DATE: 12.31.2019
TO: ProTrak
FROM: Mitesh Baxi
Traffic Engineering

■ **THE WOODLANDS AT ECHO FARMS TRACT 1 [TRC Plan Review]**

↻ Initial Review Note ↻

ROUNDBABOUT

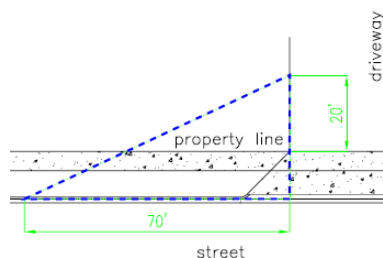
Please provide the details as per below;

- Entry angle and offset to center as appropriate
- Entry, Circulating and exit speed-radius relationships
- Inscribed diameter consistent with design vehicle (Provide autoturn analysis)

- Truck apron, if provided, consistent with design vehicle.
- Consideration for Splitter Island that accommodate pedestrian refuge as room allows.
- Please provide the reasoning for not able to provide a raised splitter island and extending it beyond the crosswalk.

- Pedestrian crossings should be set back from the yield or entrance line in the increment of a full vehicle length.
- Approach/departure, across the center island and stopping sight distances to crosswalks.

- Traffic signage and pavement markings plan.
- Vertical cross section with dimensions and grading details.
- Dimension all the design elements on plan and section details. Like splitter island, entry/exit travel lane width, crosswalk, exit radius, and as applicable.

- Provide ADA ramps as applicable.
